## **Assabet River, Massachusetts Sediment and Dam Removal Feasibility Study**

**September 2010**

**US Army Corps  
of Engineers  
New England District**

**ASSABET RIVER  
SEDIMENT AND DAM REMOVAL FEASIBILITY STUDY**

Figure 3. Assabet River Dams and Impoundments

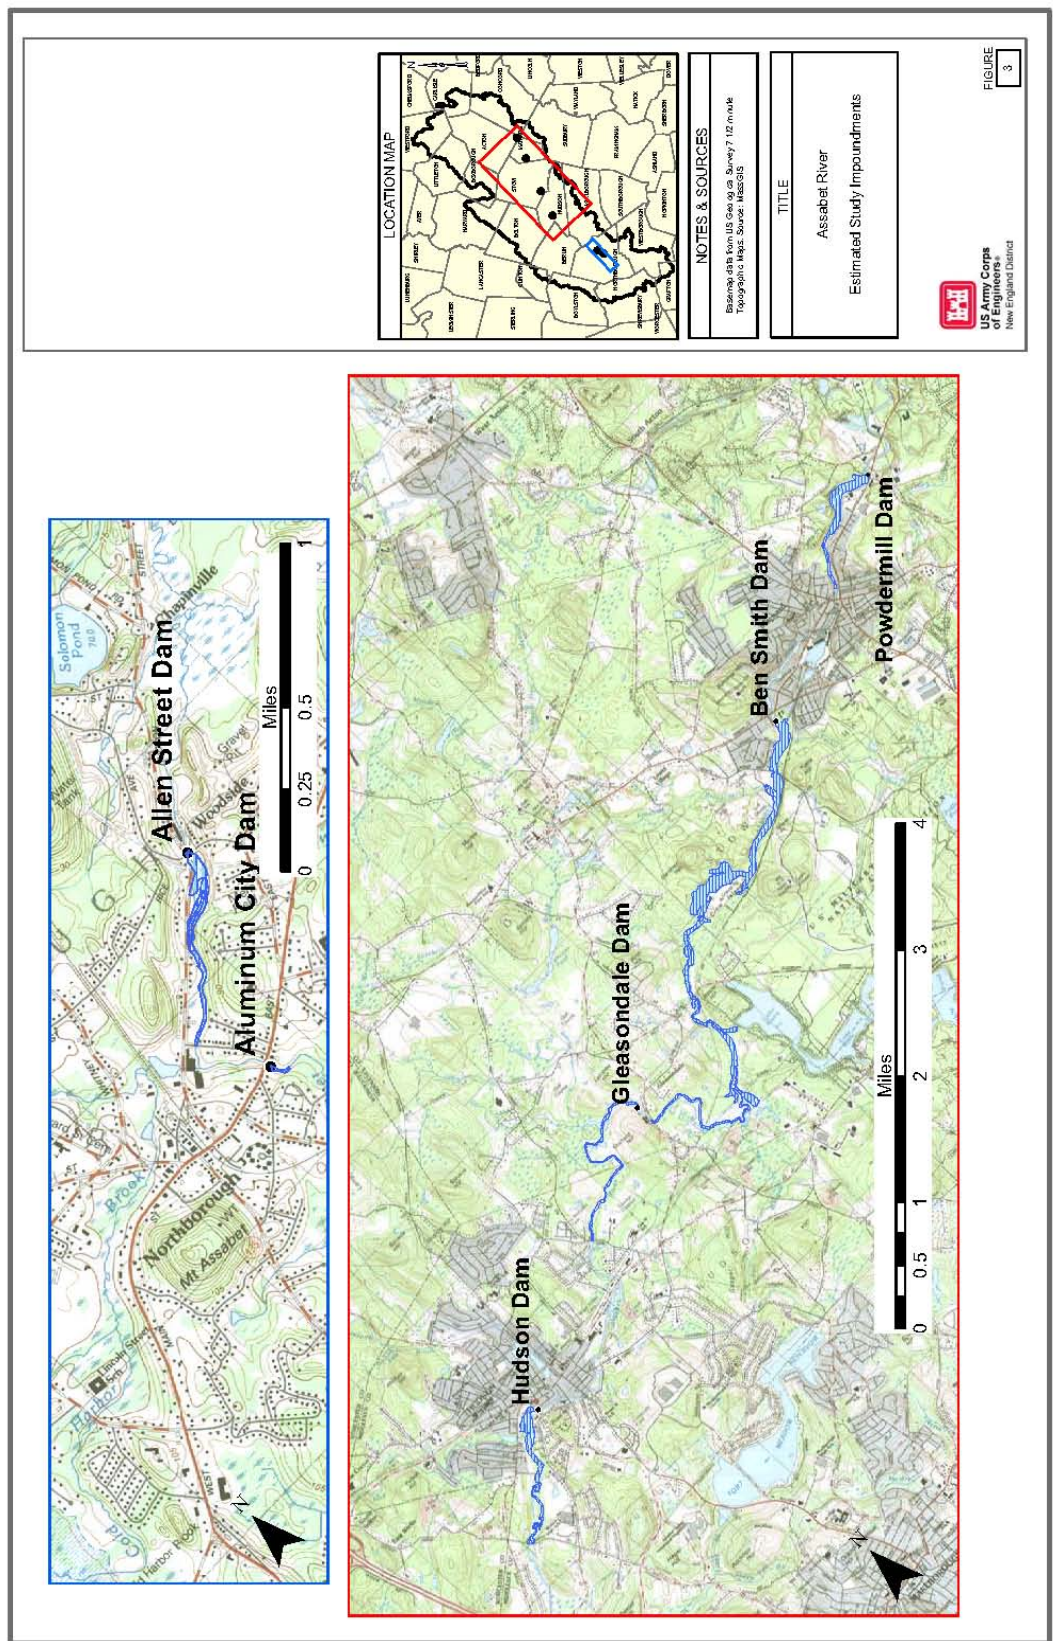
- Page 5, bottom paragraph: Please define how the Study defines the term “impoundment” behind the dams, or the “visual impoundment”, which in some cases (e.g. Ben Smith Dam) is smaller than the length of the river that is affected by the dam. See for example Figure 2 which shows a much larger length of river affected by the dam than the estimated impoundment length and area shown on Table 4, General Dam and Impoundment Characteristics.

***Corps Response: This has been rewritten in report to clarify numbers presented. A new Figure 3 has been added showing the extent of dam influence.***

2) Ben Smith Dam Impoundment Length	2.15 miles	5miles to Rt 62	6.8 miles	<u>3.2X</u>
-------------------------------------	------------	-----------------	-----------	-------------

**Corps Response:** The extent of influence of the Ben Smith Dam based on CDM modeling is approximately 5 miles. The new Figure 3 was added to report illustrates the extent of influence of the dam. The USGS report Page 40 list the length of the Ben Smith impoundment as 11,000 meters which converts to 6.8 miles. The Corps has no information to indicate that the 5 miles should be changed to 6.8 miles at this time in Table 4.
